**Amendment –VI dated 04.07.2022 on the Request for Proposal Document and Transmission Service Agreement issued for selection of bidder as Transmission Service Provider to establish “Transmission Scheme for Solar Energy Zone in Gadag (1500 MW), Karnataka: Part A-Phase-II” through tariff based competitive bidding process**

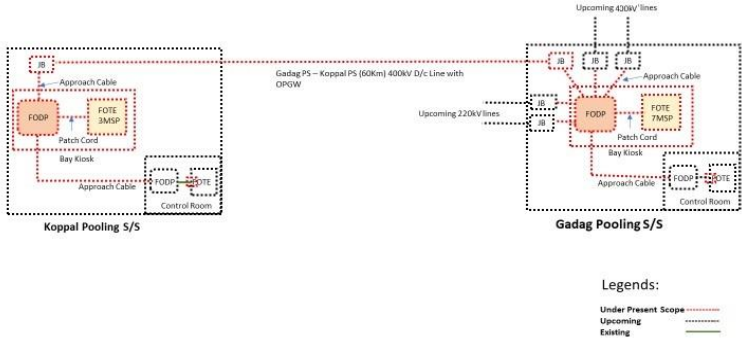
25.	Annexure C: SPECIFIC TECHNICAL REQUIREMENTS FOR COMMUNICATION of RFP & Schedule: 1 of TSA	<b><u>C.3.0: 2 no. of 400 kV line bays at Gadag PS end for Gadag PS Koppal PS 400kV D/c line</u></b>  .....	<b><u>C.3.0: 400/220 kV, 3x500 MVA ICT Augmentation at Gadag Pooling Station</u></b>  .....
